Monks Orchard Residents' Association Planning

Reference 21/00222/FUL
Alternative Reference PP-09430433
Application Received Mon 18 Jan 2021
Application Validated Wed 17 Feb 2021

Address 211 Wickham Road Croydon CR0 8TG

Proposal Demolition of the existing outbuildings to the rear of the shop

Access Driveway at boundary of #2 Ridgemount Avenue Showing the 1.8m Tall Fencing up to the boundary of the Public footpath, precluding any visibility splays to the North as viewed from the Exit from the New Parking Bays into Ridgemount Avenue.

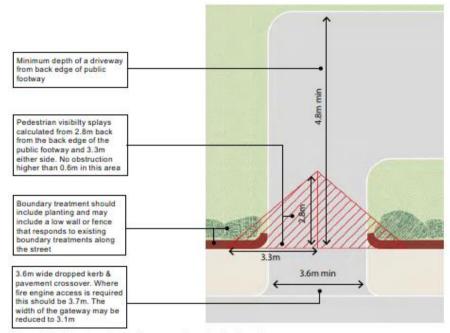
It is noted that the ≈1.8m Close Boarded fencing on the side boundary of 2 Ridgemount Avenue precludes any visibility splay of the footpath to the north when exiting the new access driveway for the proposed car parking bays into Ridgemount Avenue. It may be possible for the applicant to negotiate a reduction in height of the first fence panel, to less than 0.6m high at the entrance to the side passage to allow safe sight lines to be available for safe exiting from the new parking spaces.

SPD2 Policy 2.29 e) states: For "Pedestrian Visibility Splays from 2.8m back from the back edge of the public footway and 3.3m either side there shall be no obstruction higher than 0.6m".
